EL MONTE UNION HIGH SCHOOL DISTRICT

April 14, 2023

TO : All Bidders
FROM : El Monte Union High School District
BID # : 2022-23(B8)
PROJECT : Mountain View HS Modernization Project
SUBJECT : Addendum No. 2

1. LPA Architects Addendum No. A issued April 14, 2023 attached.

AK-1.41

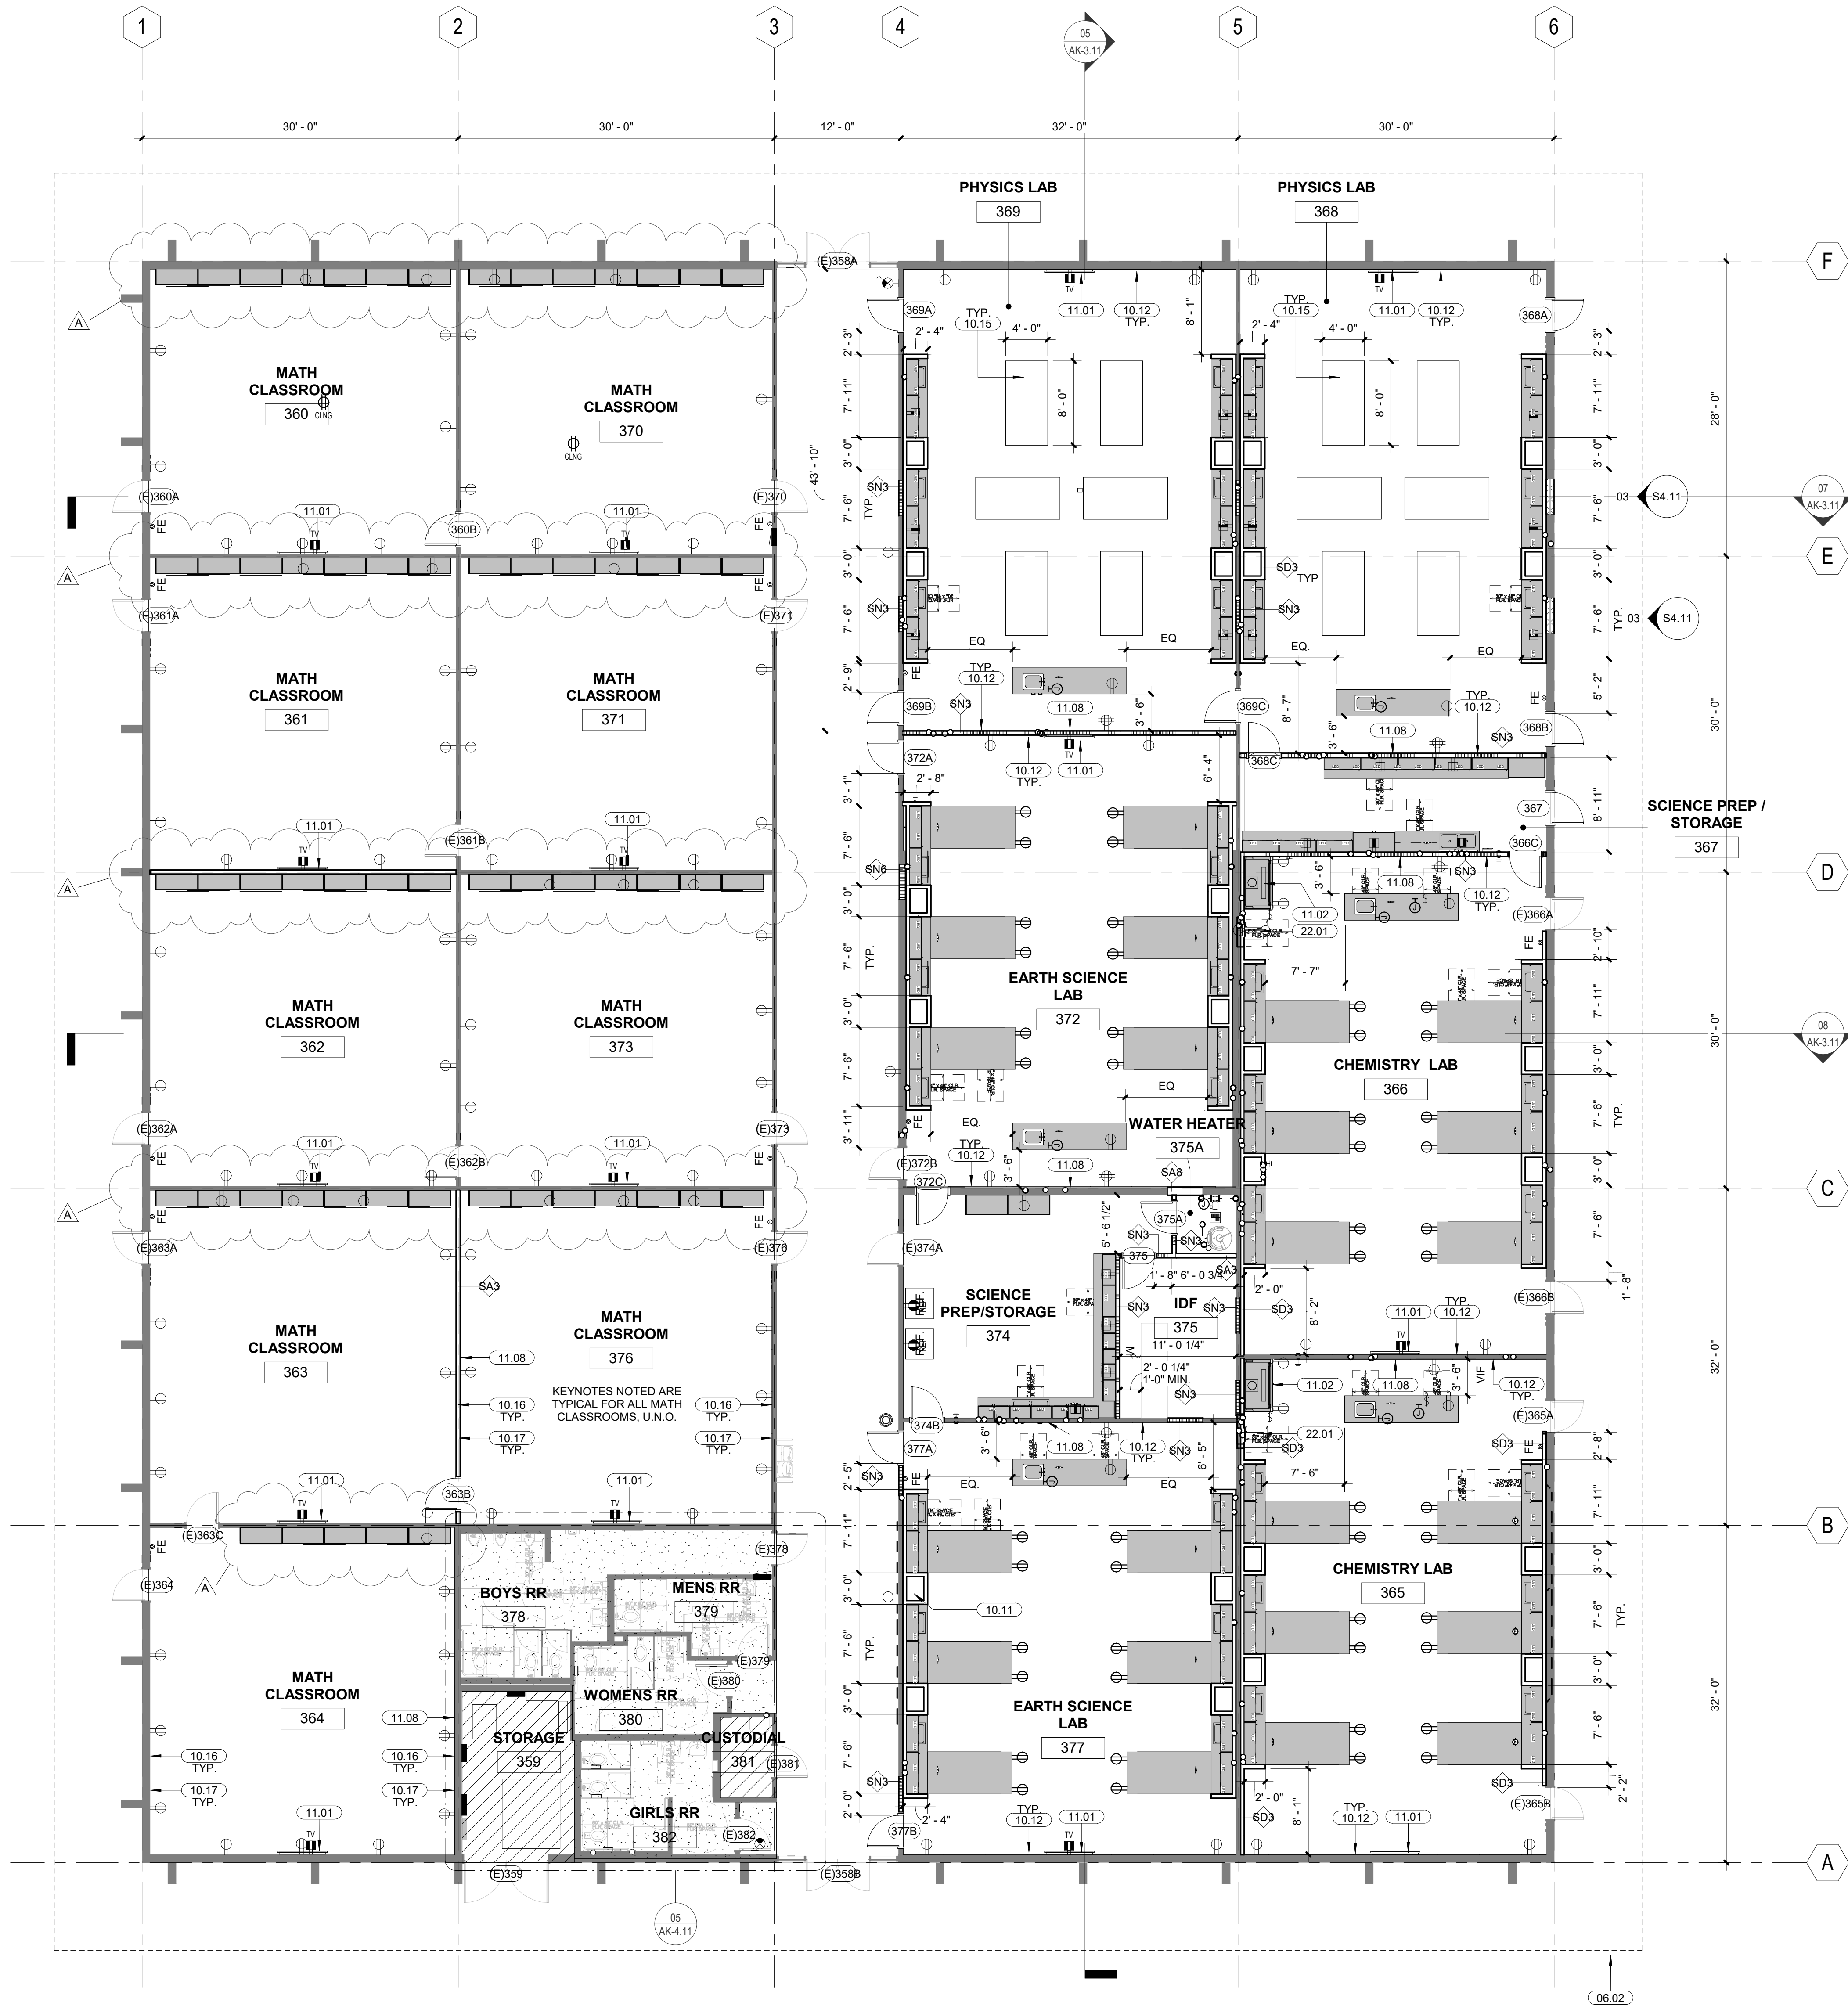
- Item No. 34** **Sheet AK-1.41 – Demo Roof Plan**
(a) Revised keynote 07.06 to 07.14 for existing roof baffle

RECONSTRUCTION
FLOOR PLAN

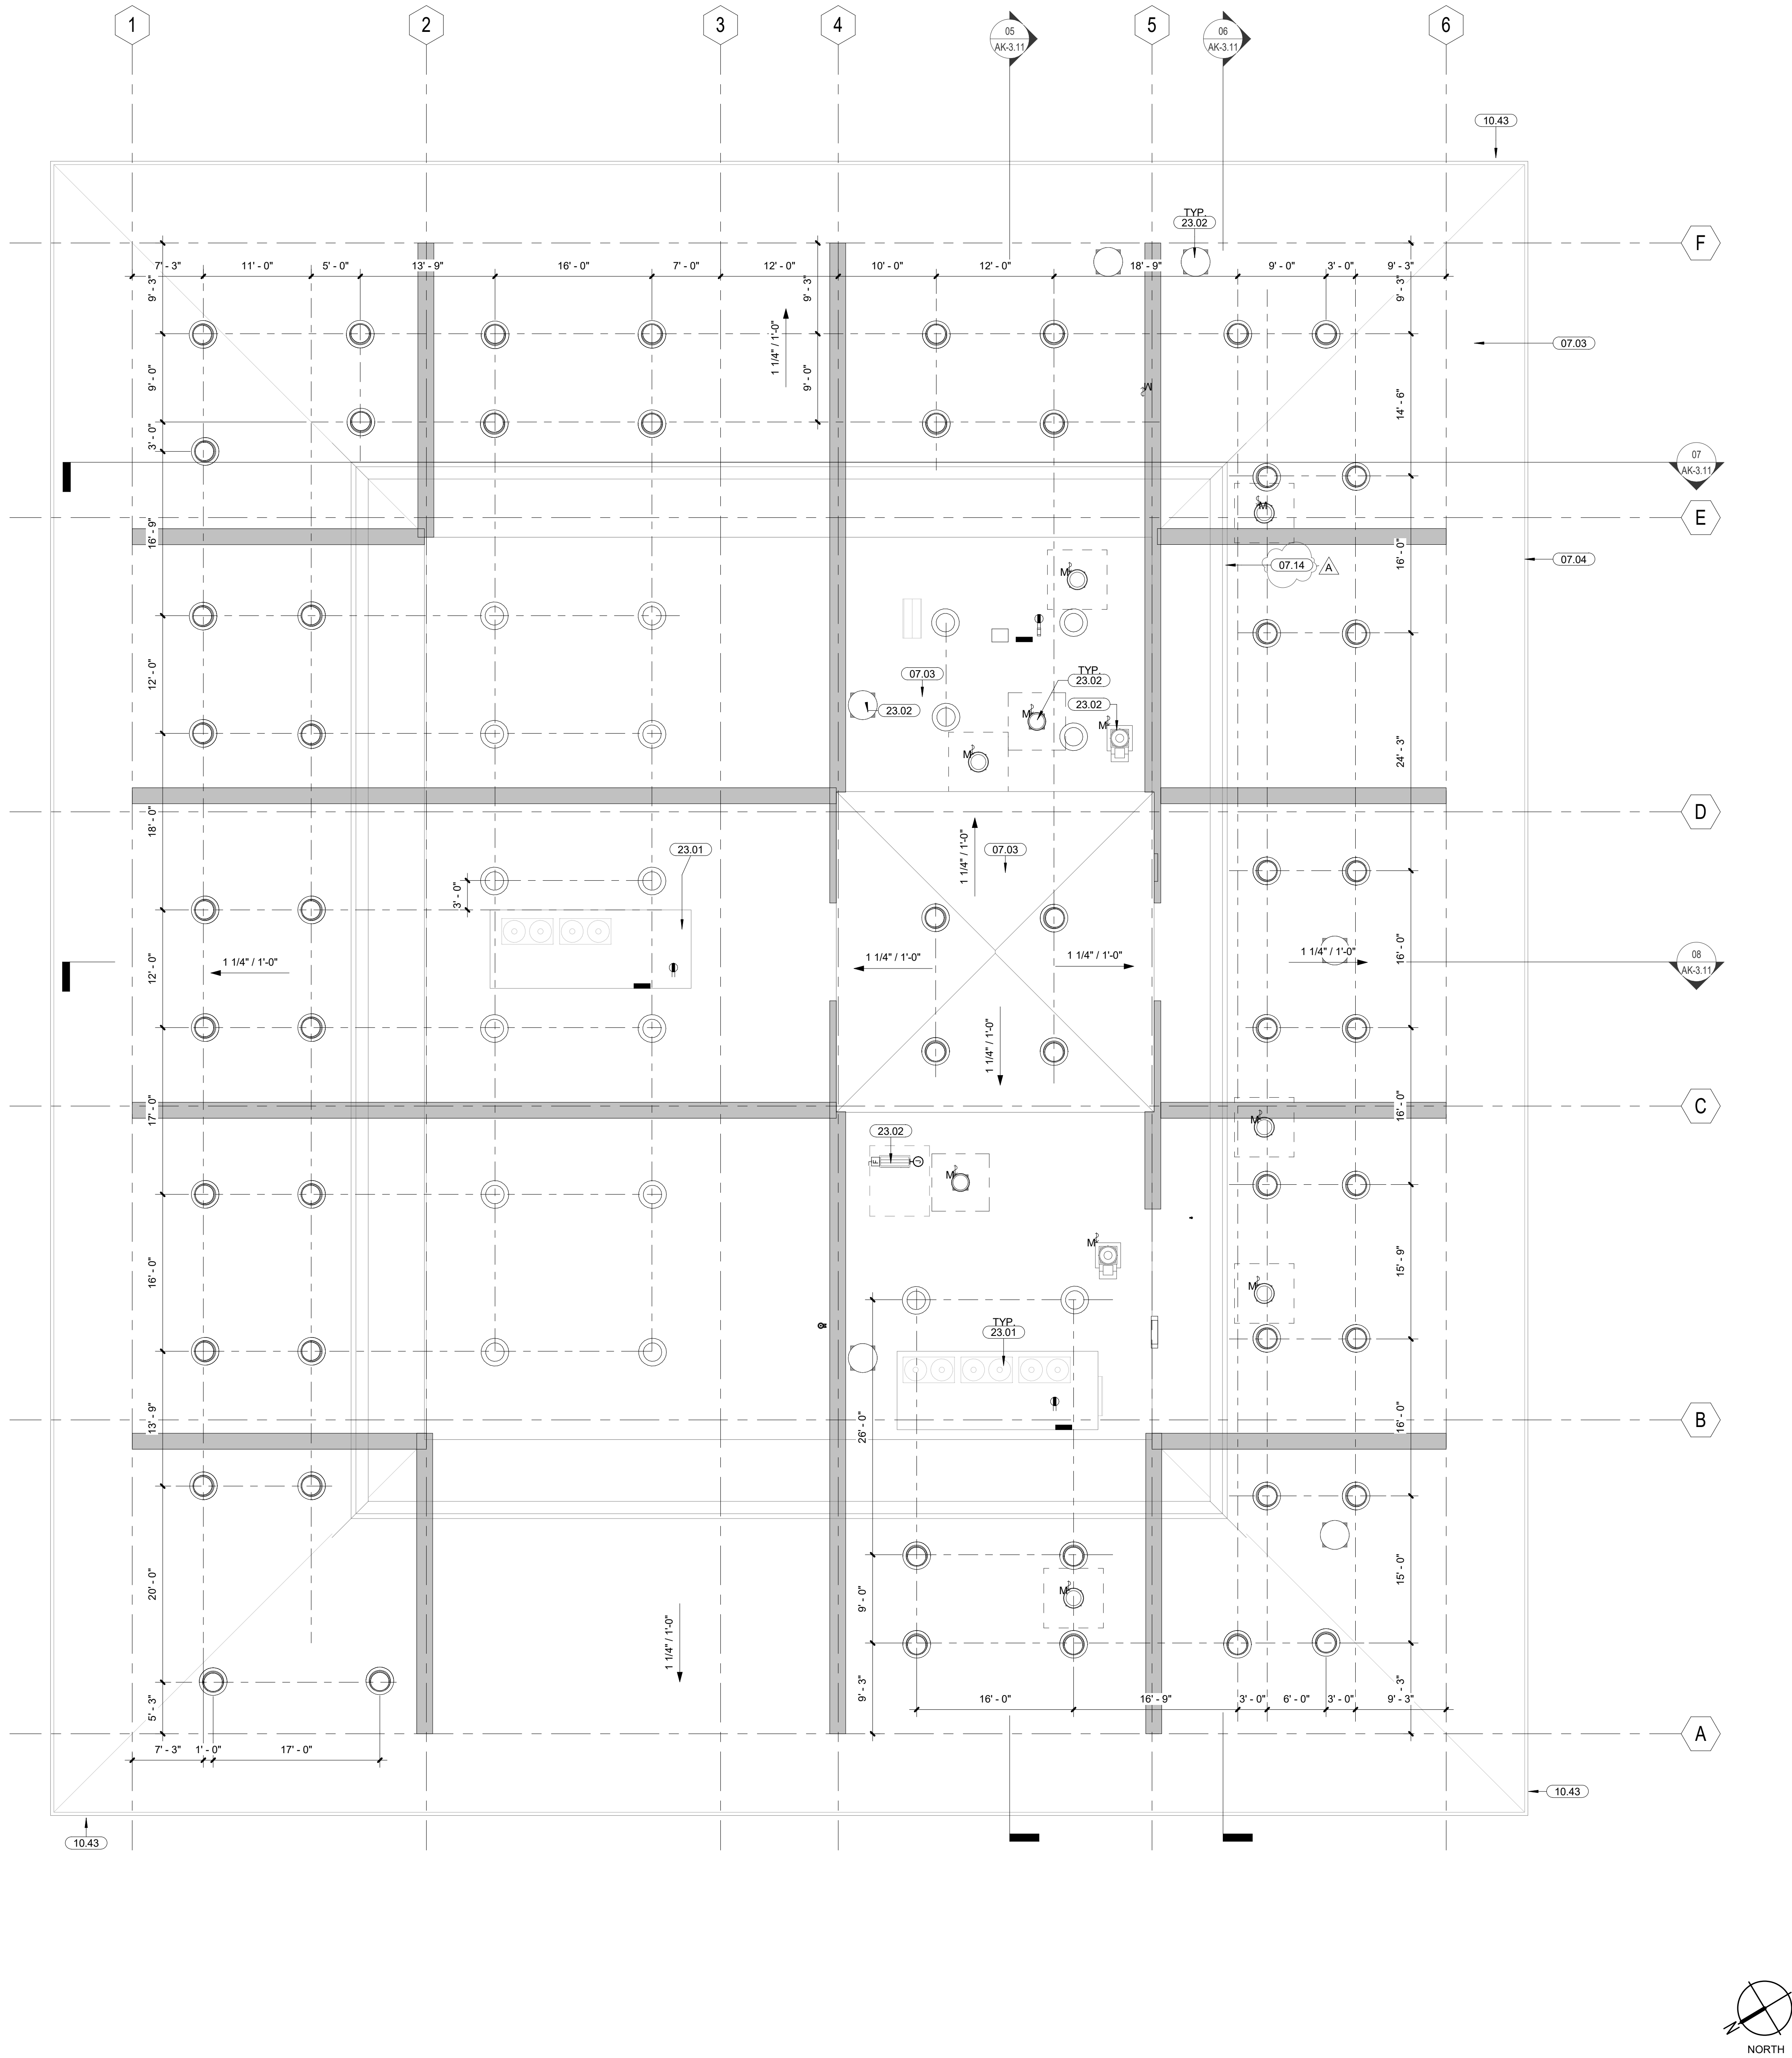
Pre-Bid-22	Per Floor Plan AK-2.11, the casework for the Math Classrooms is not shown shaded grey to indicate new casework.	Closed		None	Grandy, Stephen	04/05/2023	Stephen Grandy	04/15/2023	04/07/23

- Item No. 35** **Sheet AK-2.11 – Reconstruction Floor Plan**
(a) Revised hatch pattern at math classrooms to indicate new casework

AL-2.41

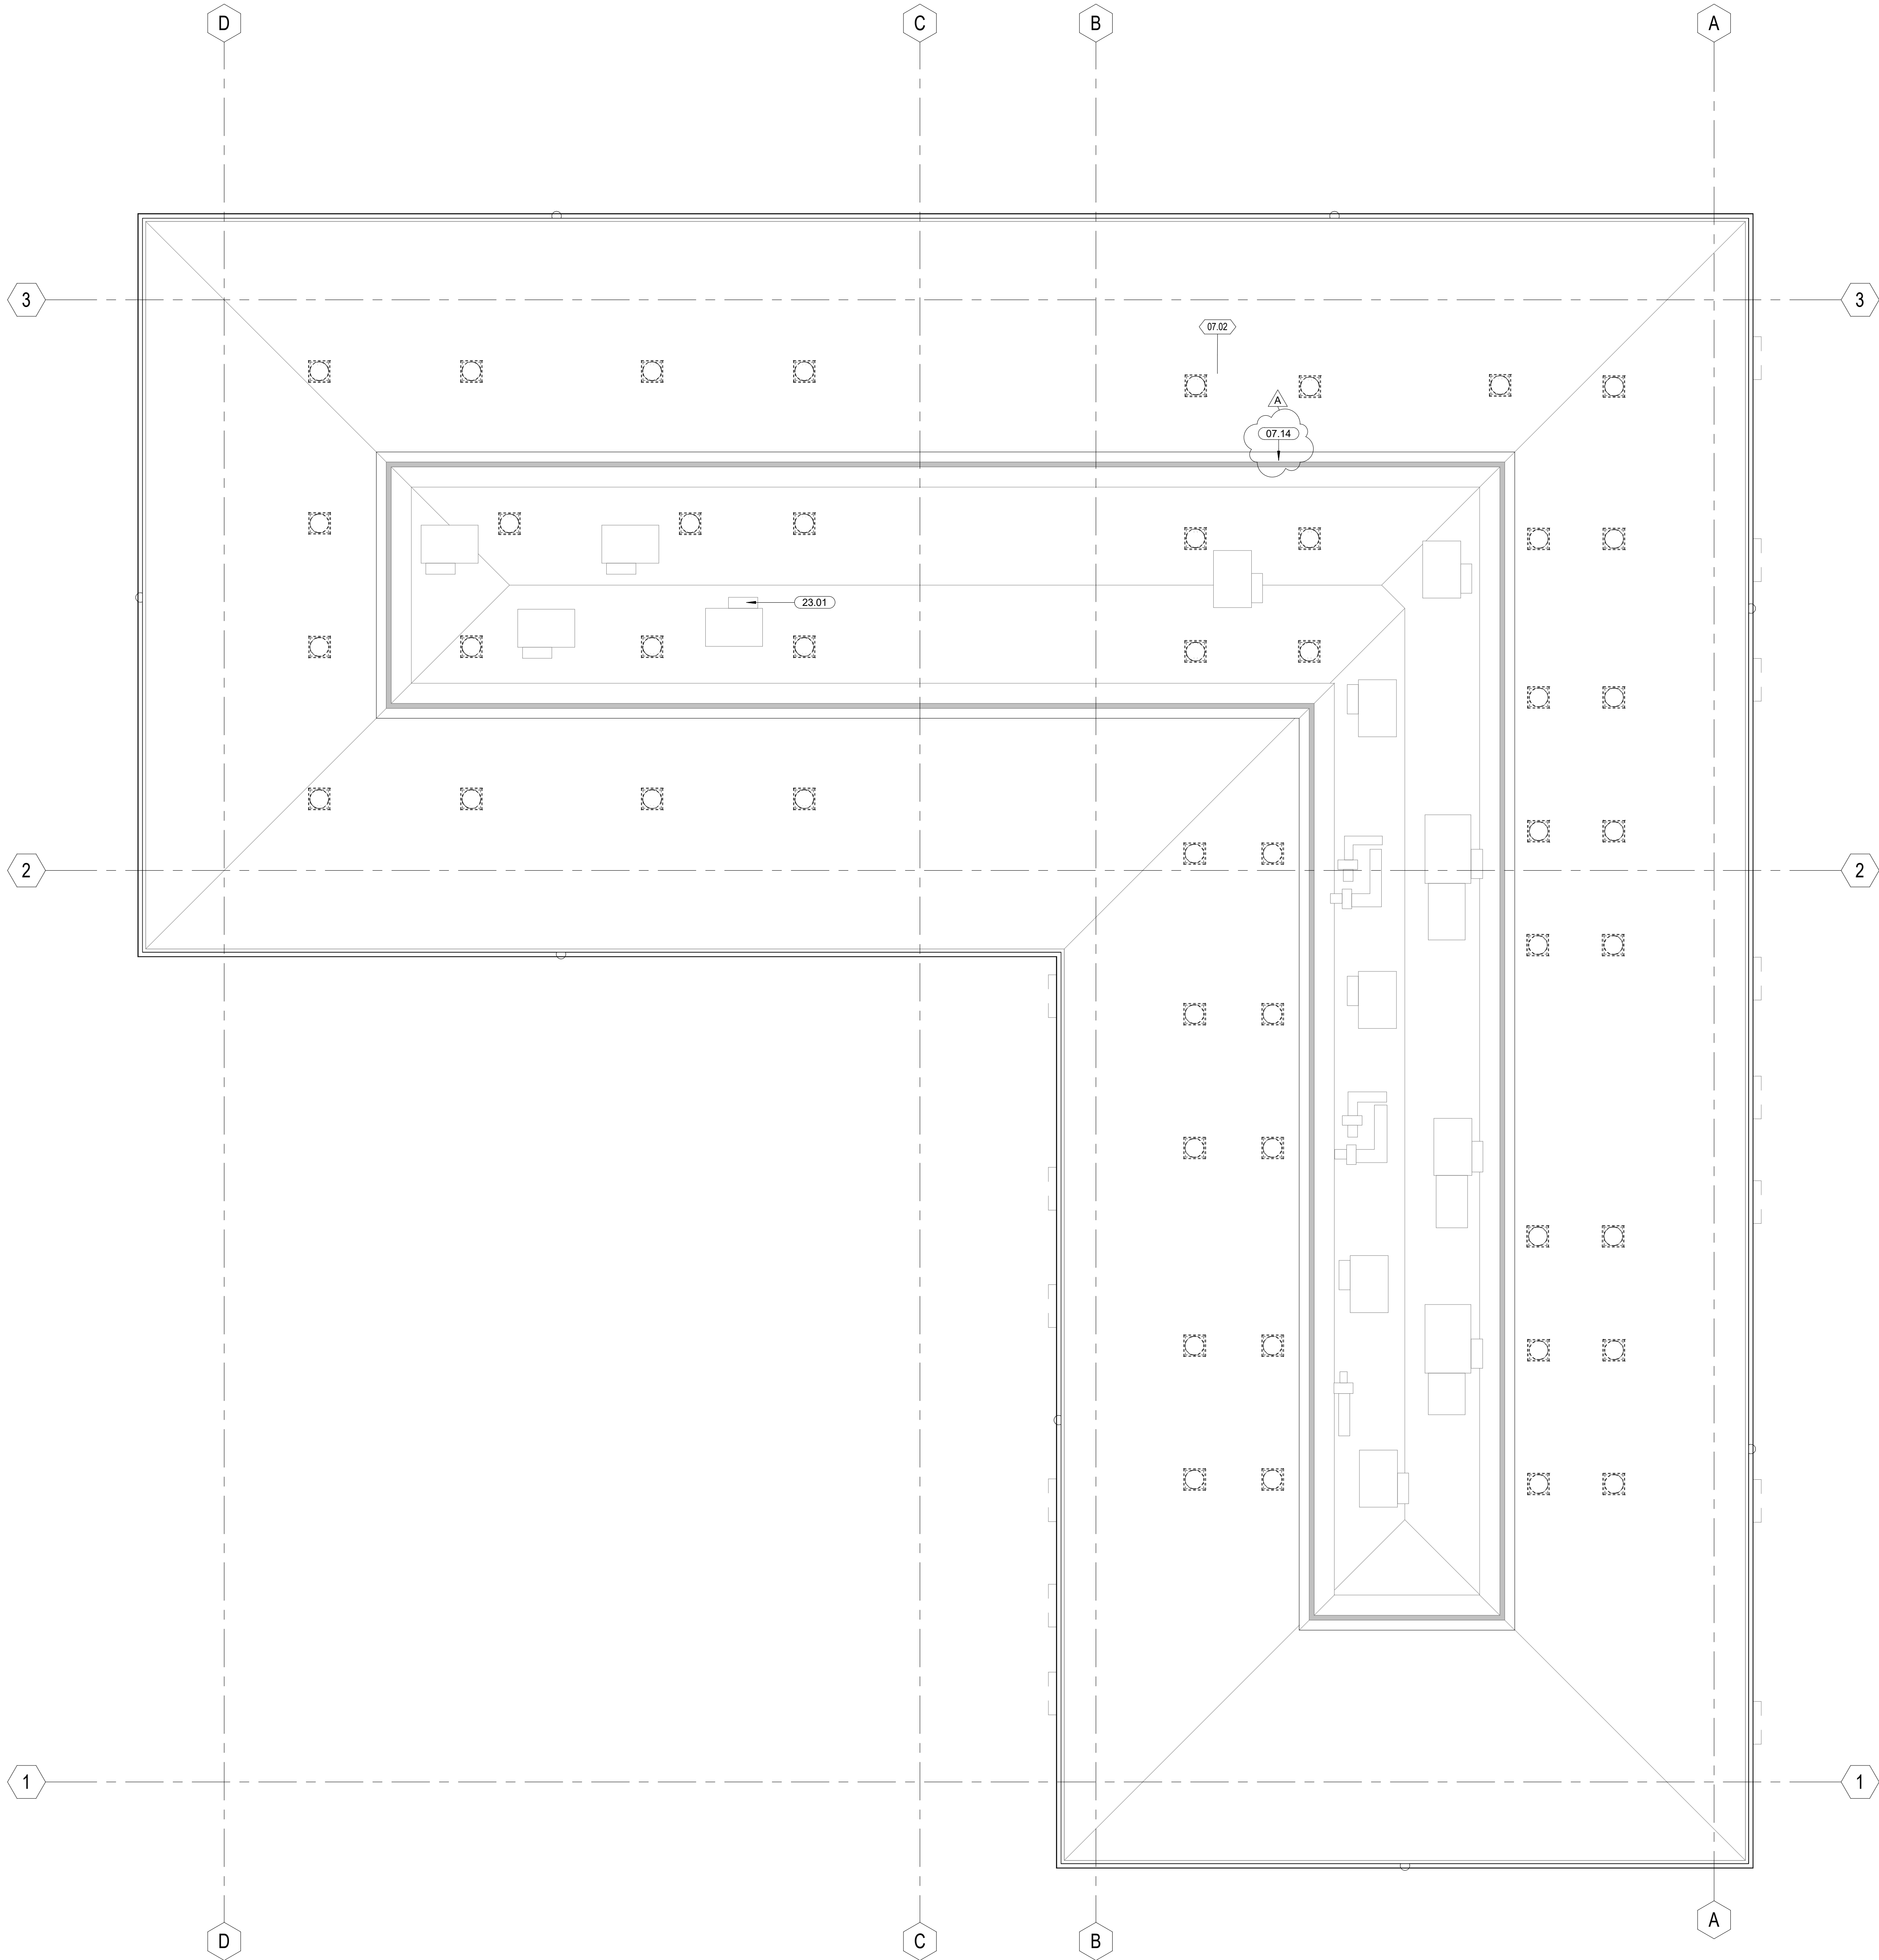
- Item No. 37** **Sheet AL-2.41 – Reconstruction Roof Plan**
(a) Revised keynote 07.06 to 07.14 for existing roof baffle
(b) Added keynotes 07.02, 07.03, and 07.04 for new roofing and reactivated integral gutter
